ADDENDUM NO. 03
TO THE
CONTRACT DOCUMENTS

FOR
TAXIWAY A REHABILITATION (WEST)

AT
SYRACUSE HANCOCK INTERNATIONAL AIRPORT
SYRACUSE, NEW YORK

AUGUST 11, 2023

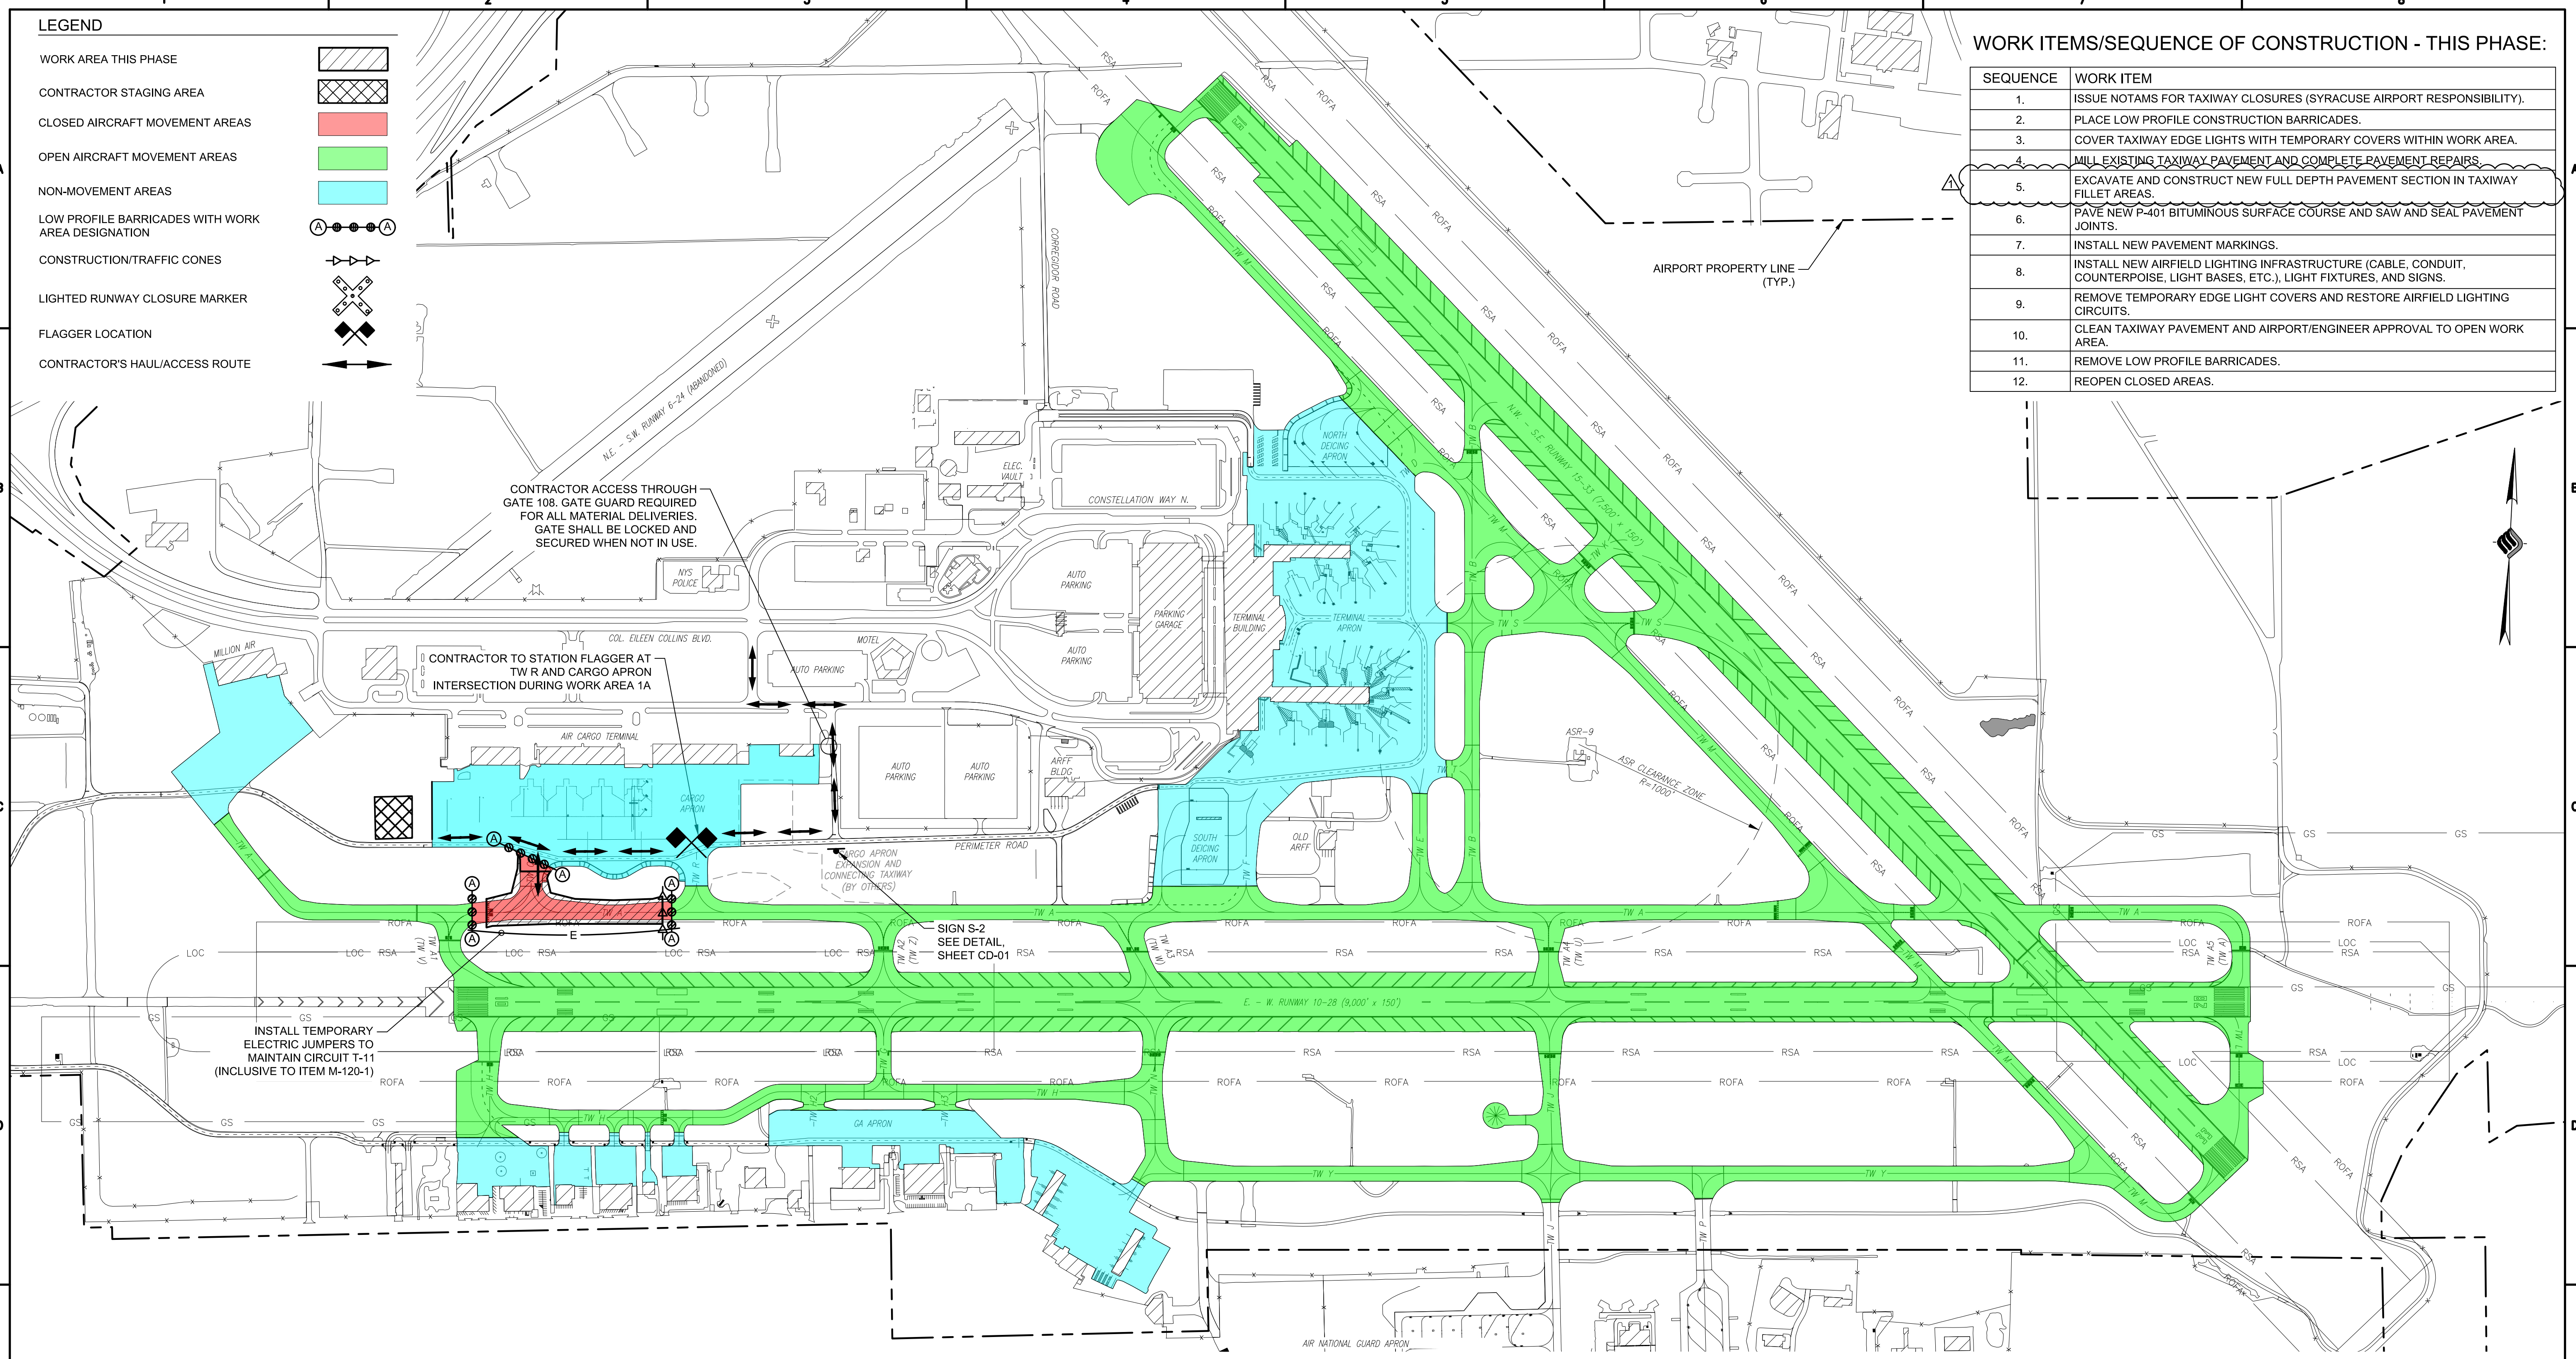
Clarification: The 'Work Items/Sequence of Construction – This Phase' Table has been updated on Drawings CS-01A through CS-05A to remove an erroneous entry referencing paved shoulders and replace it with an entry referencing the proposed work. The 'Phase Requirements' Table has been updated on Drawing CS-06A to correct the erroneous 'Phase' entry.

GRADING & EROSION CONTROL
DETAILS (SHEET 2 OF 2)

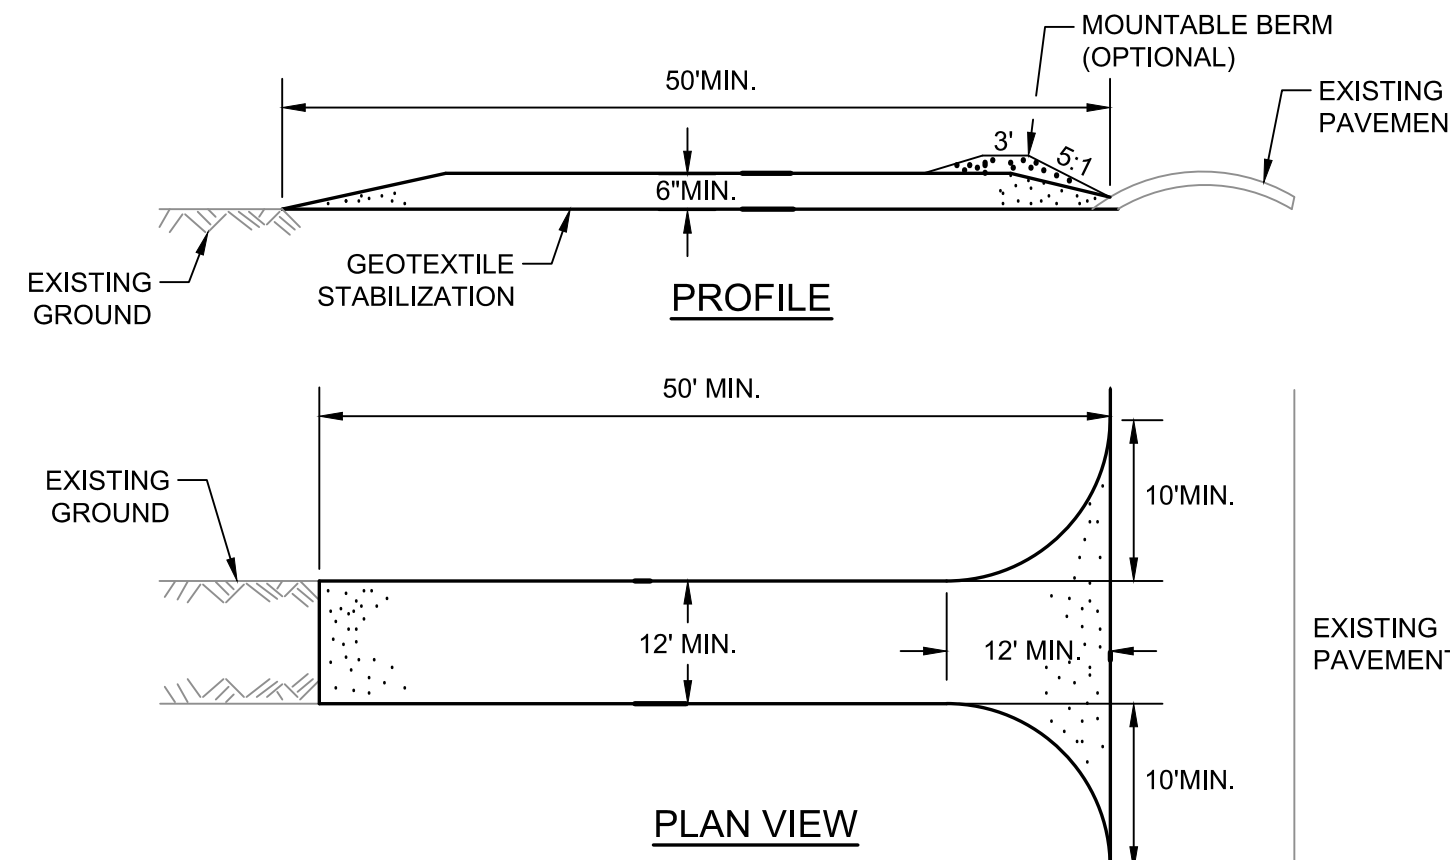
Clarification: Relevant item numbers have been added and detail notes clarified.

REV	DATE	DESCRIPTION	BY
△	8/11/2023	REVISED DETAIL 2 - ADDENDUM 3	SGJ
△	8/11/2023	REVISED DETAIL 3 - ADDENDUM 3	SGJ

EXISTING REMOVAL DETAILS

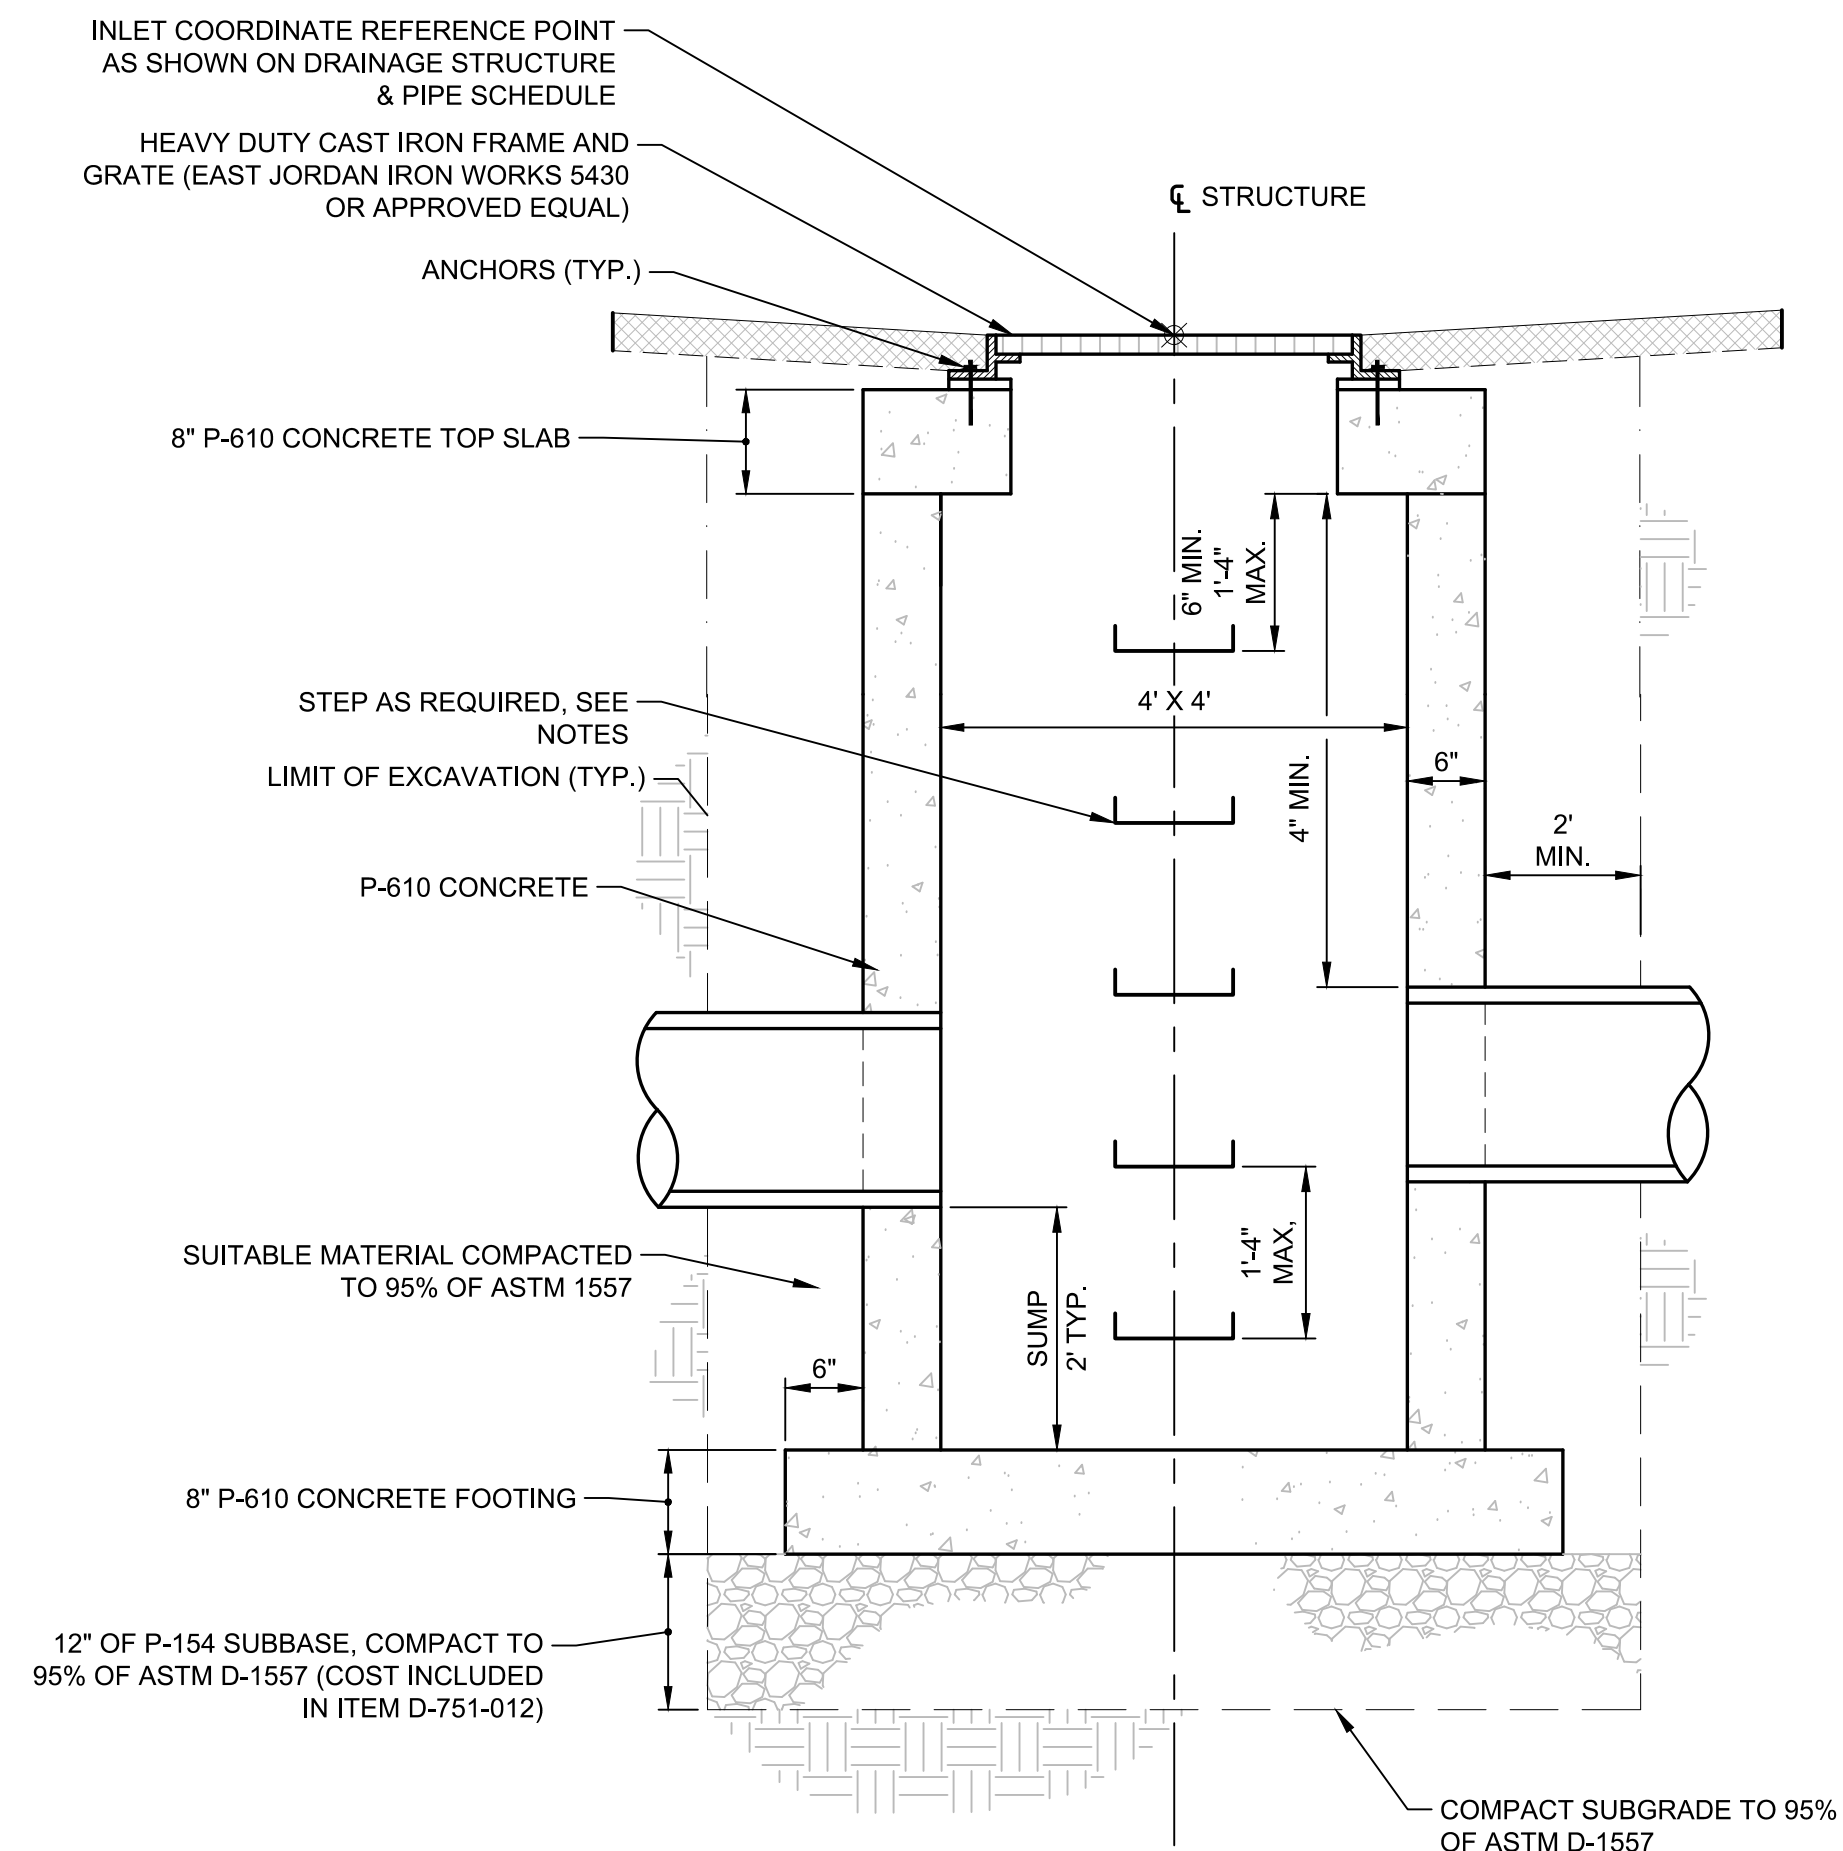
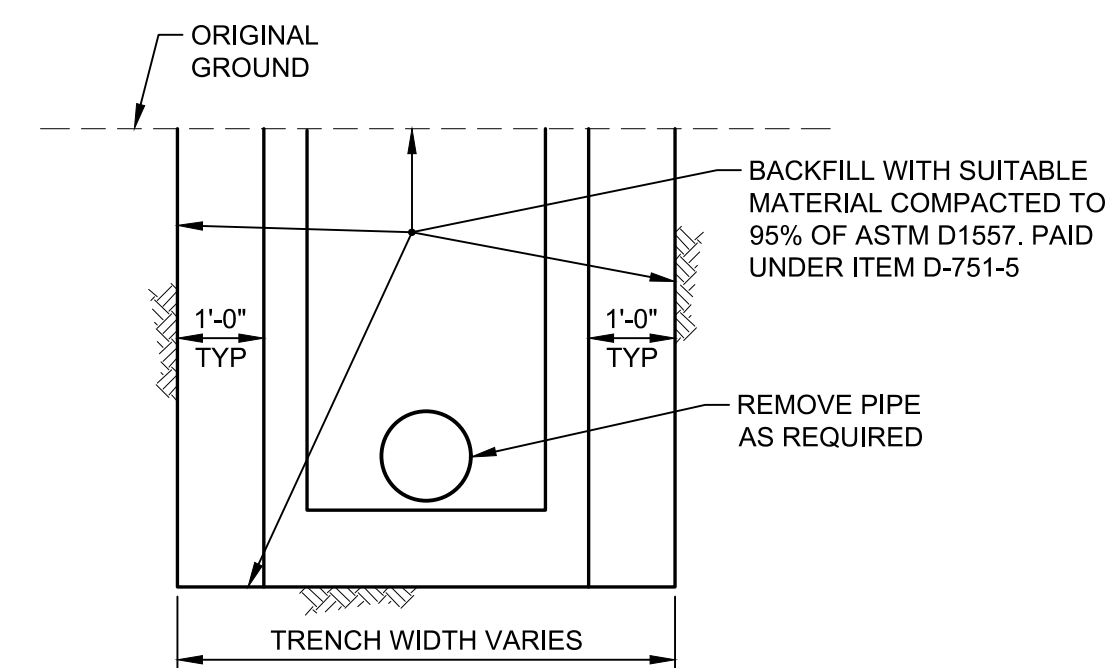
Clarification: 'Existing Removal' detail has been updated to remove an unused item number and associated detail drawing.

REV	DATE	DESCRIPTION	BY
	8/11/2023	REVISED DETAIL 4 - ADDENDUM 3	SGJ
